ADDENDUM #3

August 27, 2025

**CRAWFORDSVILLE READINESS CENTER MODERNIZATION
INDIANA NATIONAL GUARD
CRAWFORDSVILLE, INDIANA**

IFB NO: MDI-SAB-26-B-013

ABI1
A320

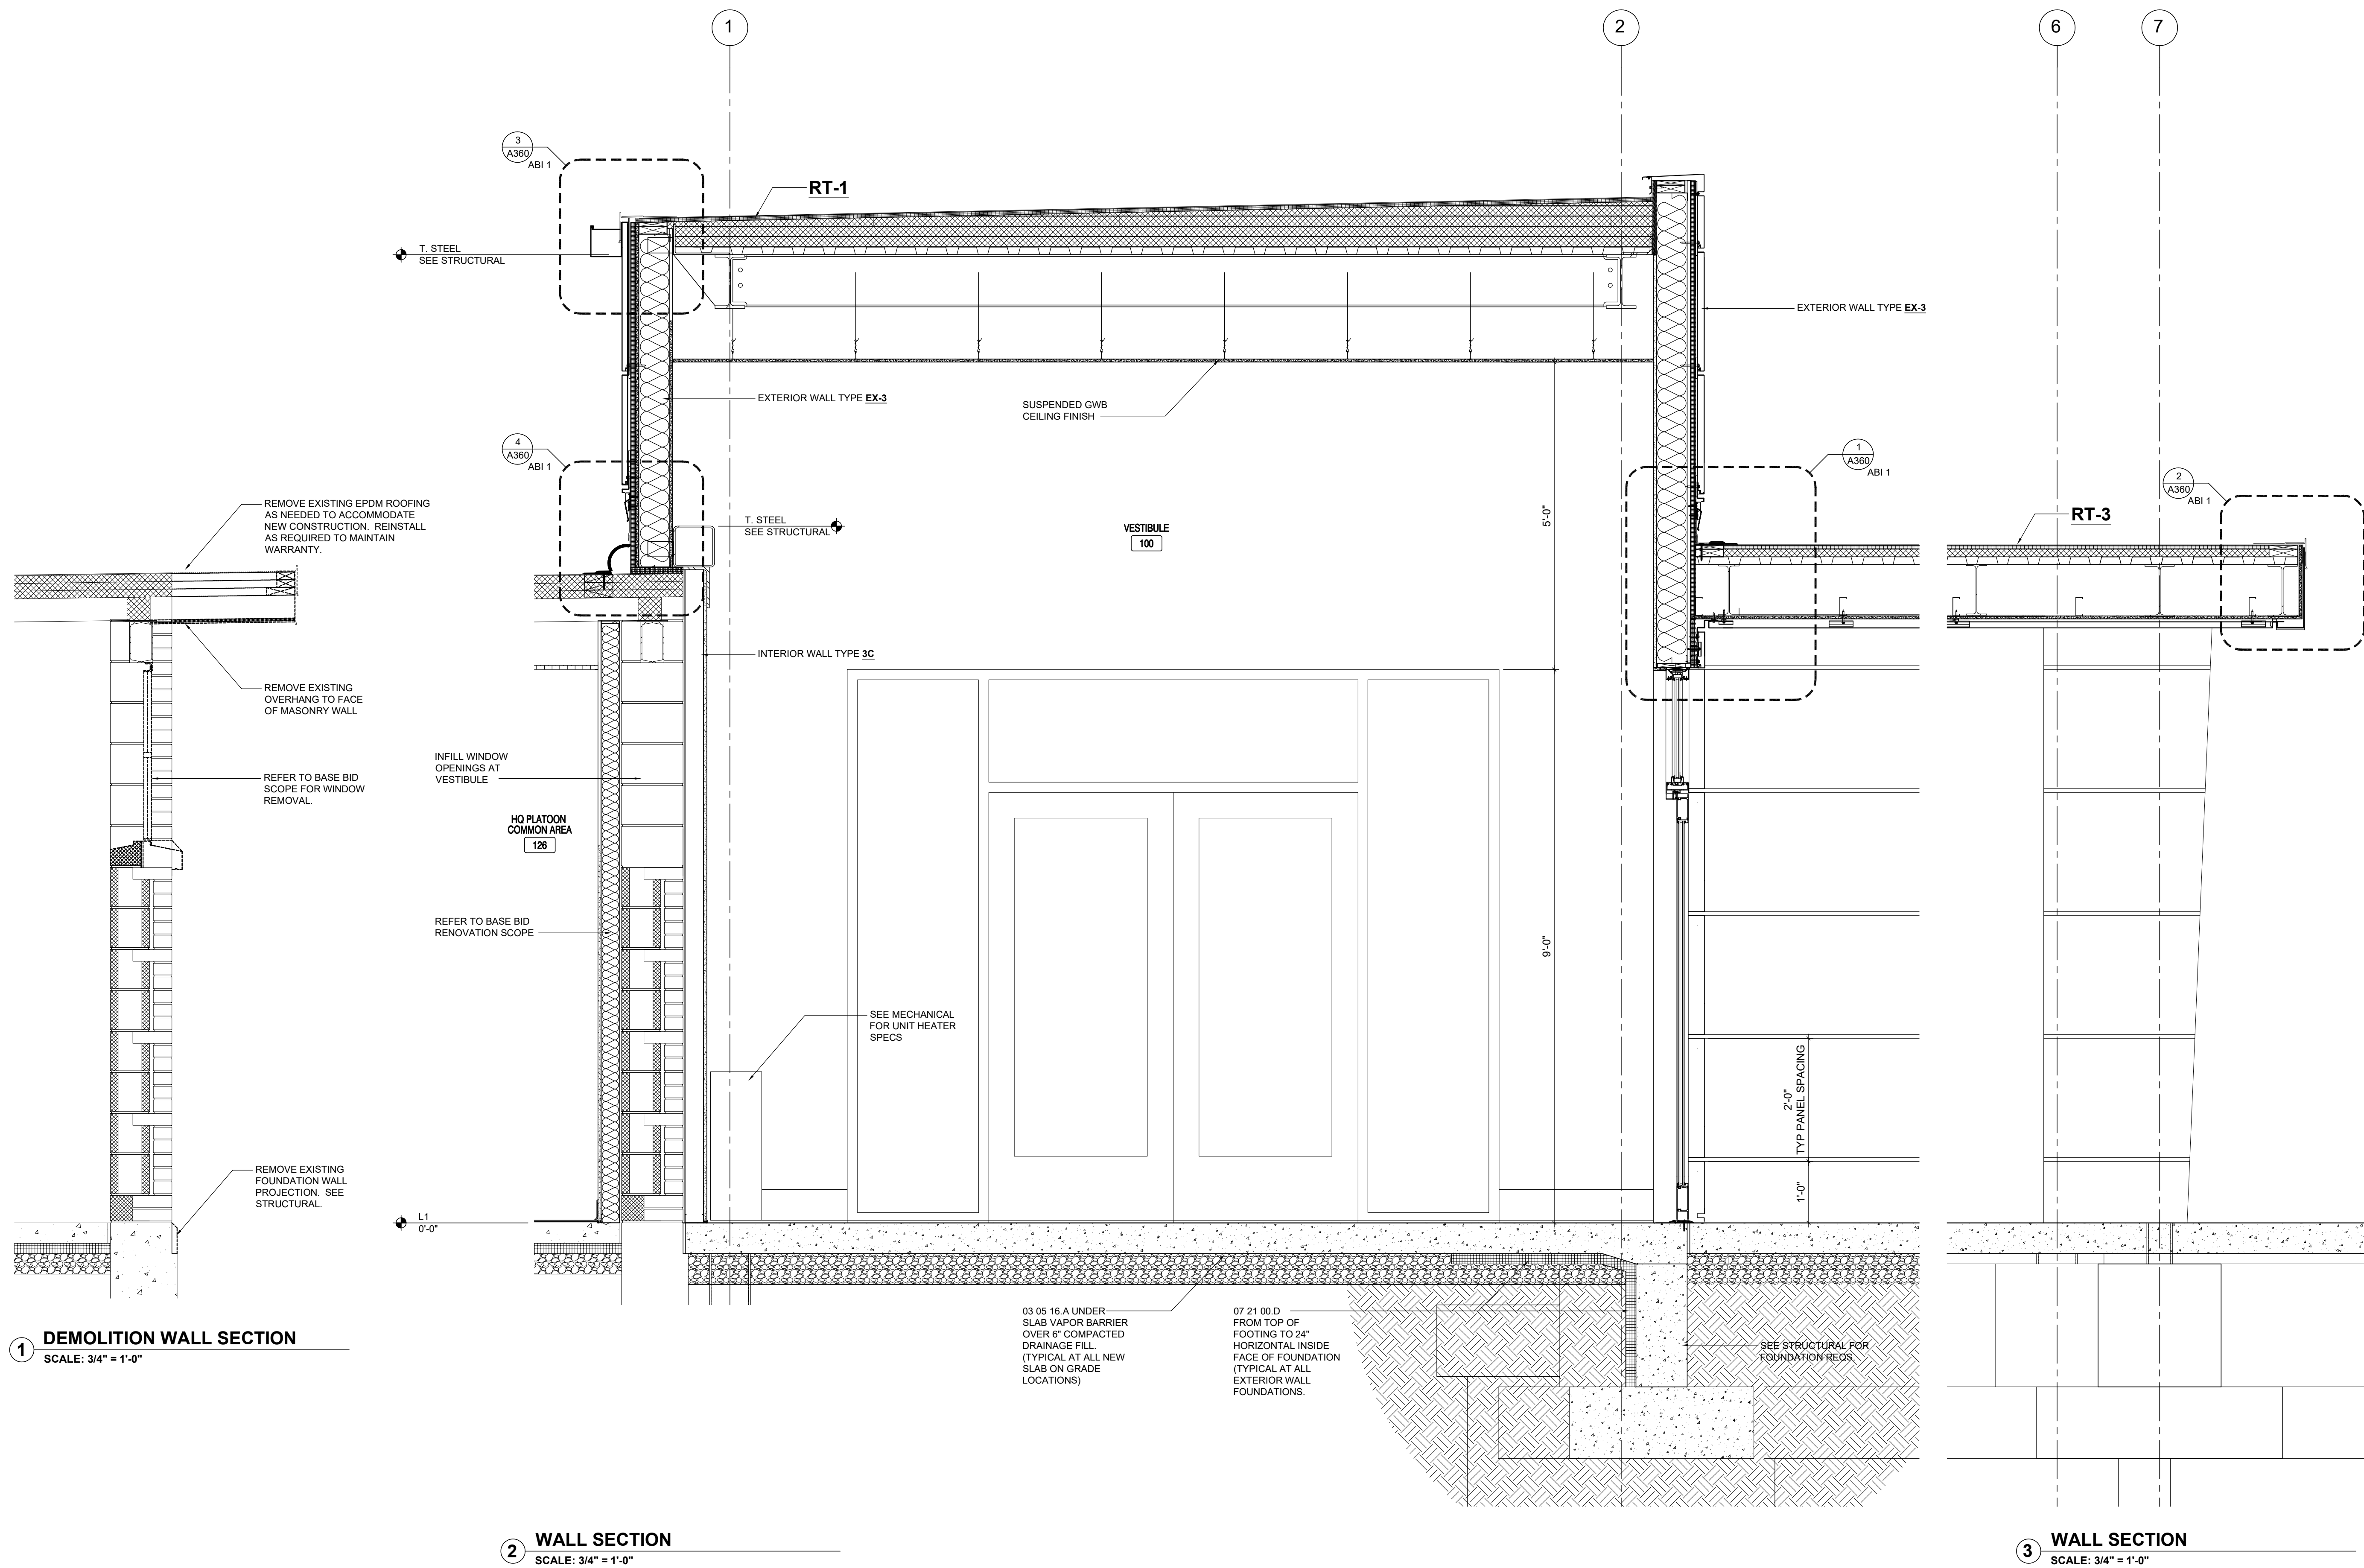
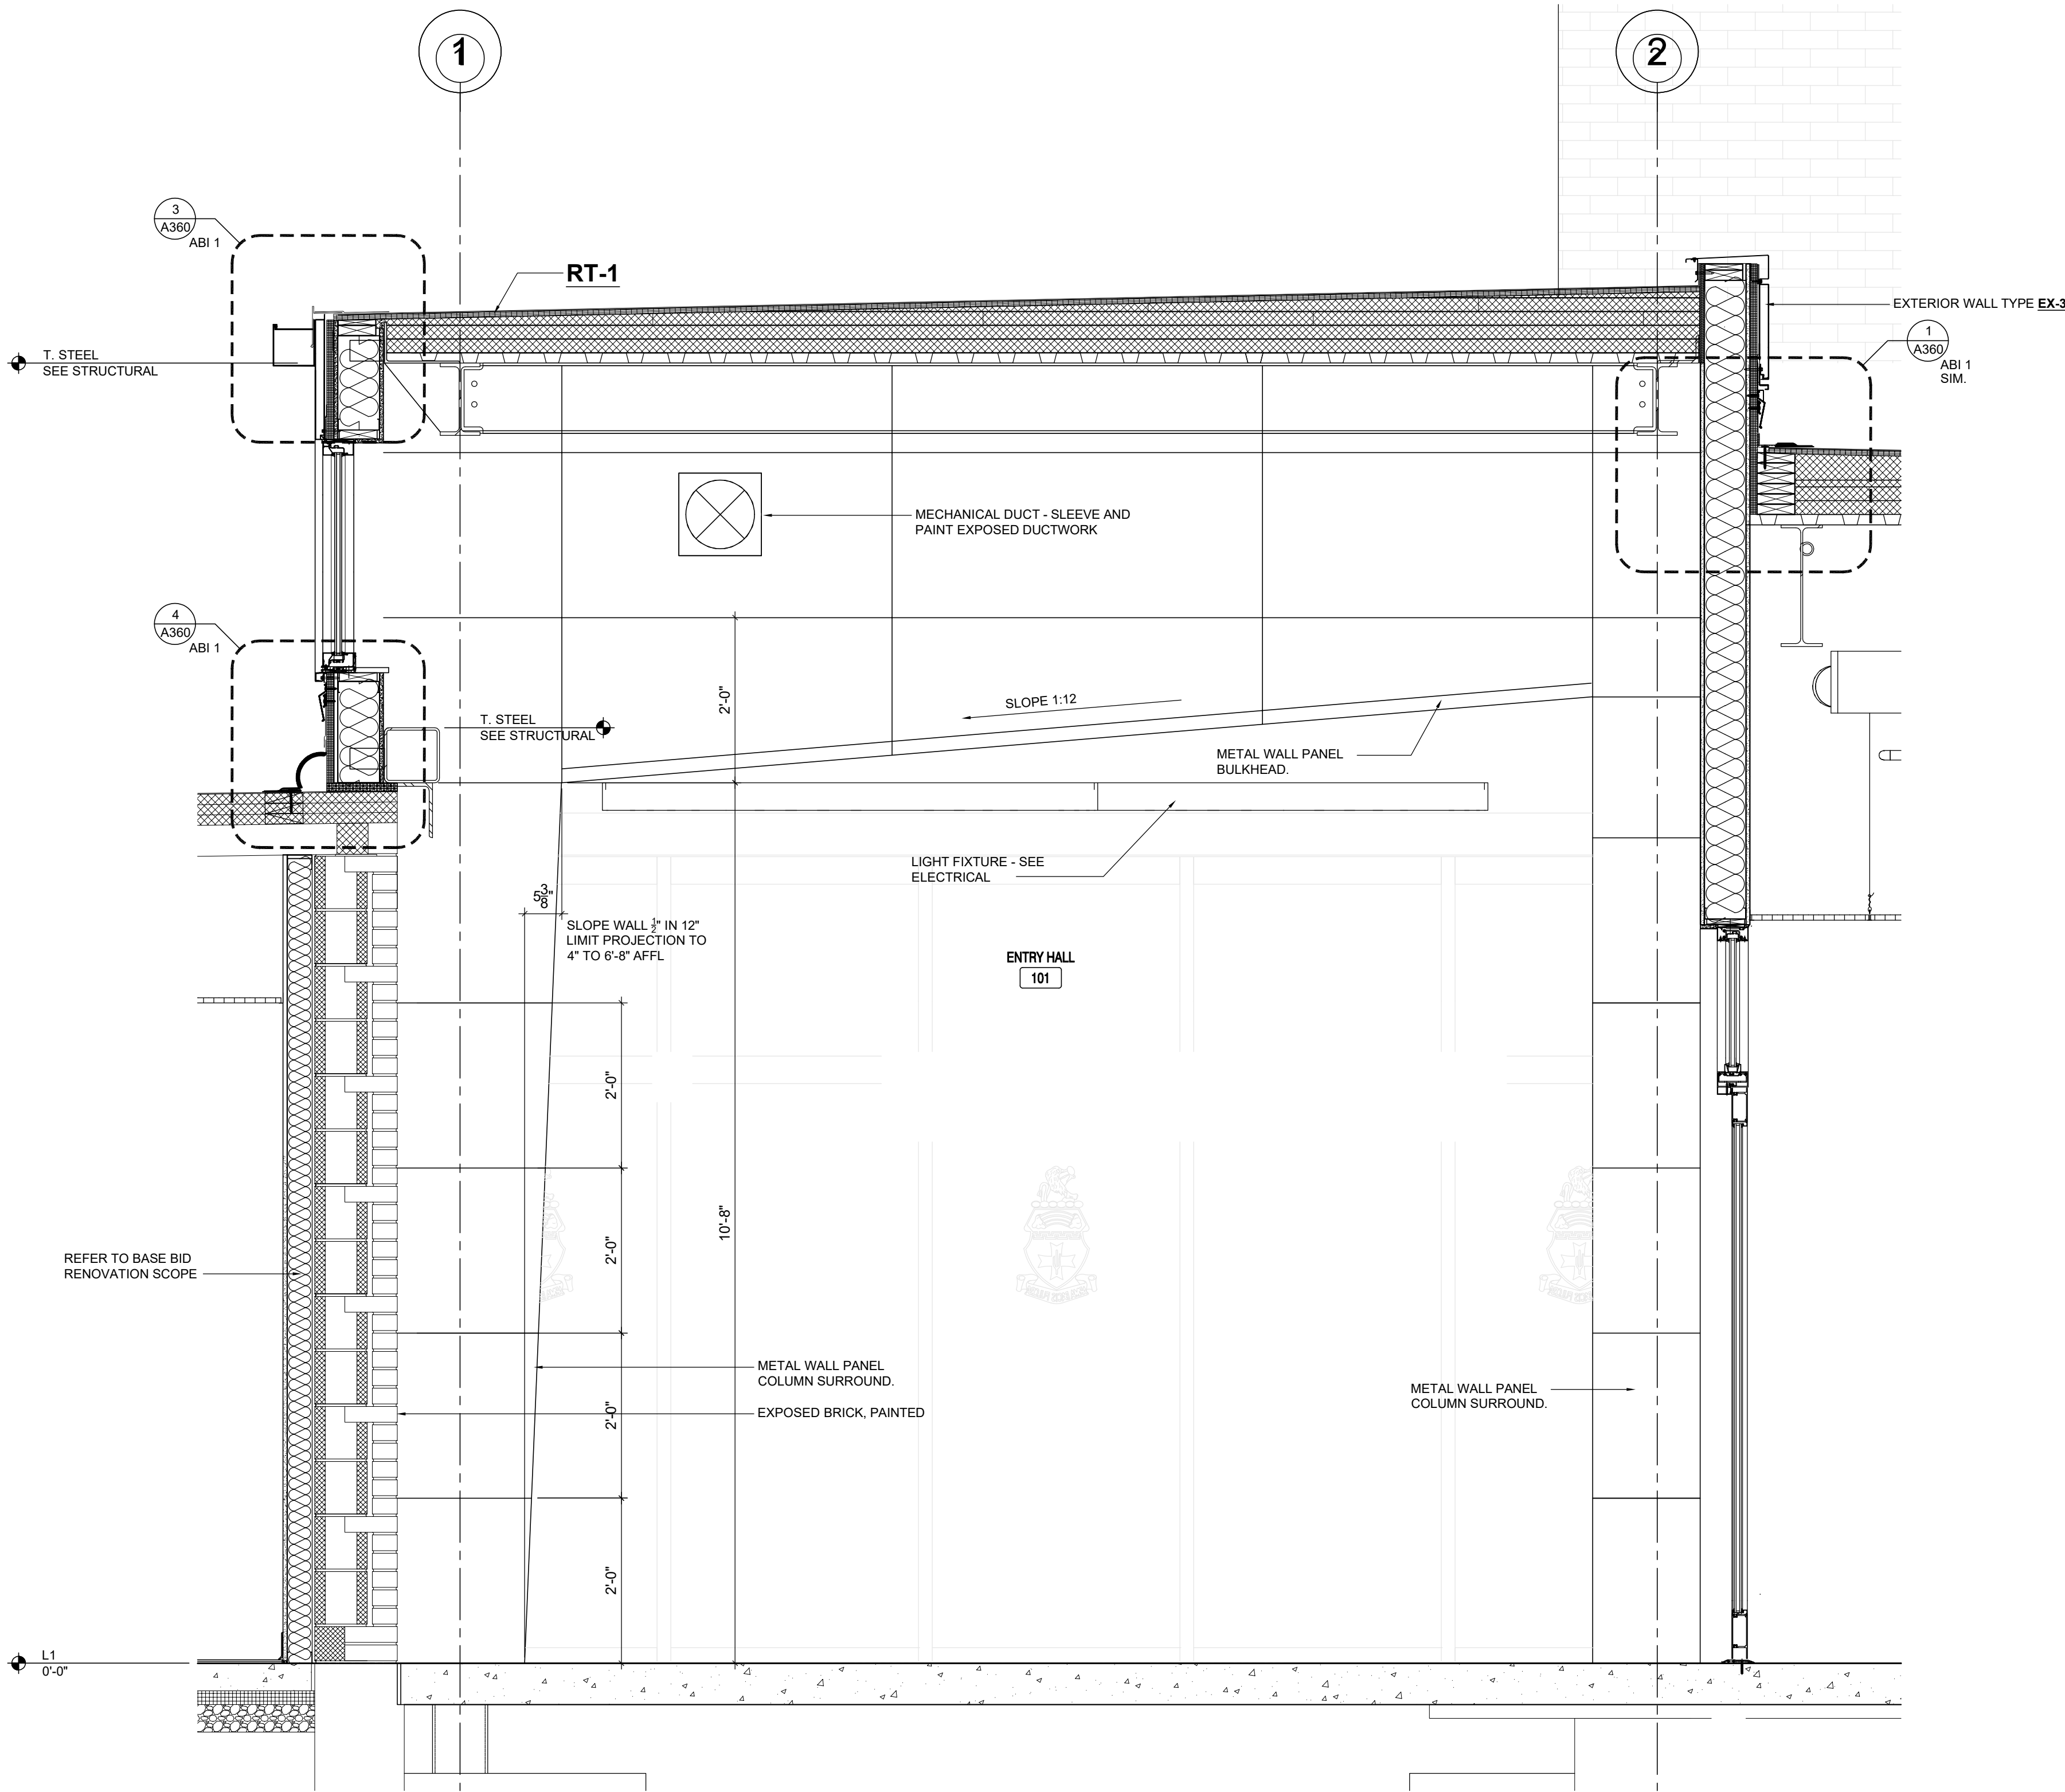
- Response: **This is a metal box beam header, wrapped in aluminum to match the storefront. Refer to A323 attached to this addendum.**
26. Question: Referring to the previous section cut, doors 100C are shown at the interior and are also referenced as Frame 'S17'. However, it appears that the interior frame S17 runs the full height of the opening with no 1'-0" horizontal separation. This seems to match the elevation of 100C shown on section 6-6 on the same sheet (please see below). Should this S17 run the full height with no interruption?

- Response: **Provide the lower portion of glazing only for this opening See A320, attached to this addendum.**
27. Question: At Base Bid, sheet A601 Door Schedule General Note 4 states that the Fire rated openings 110A C 110B need to be a Fireframe Heat Barrier Series with Pyrostop glazing. This is a Technical Glass Products item. Their UL ratings are dependent upon them using tested hardware (provided by TGP). At this opening, are you looking for Panic Devices and Closers or will there be any special needs (Electric retraction, Monitoring, etc.)?
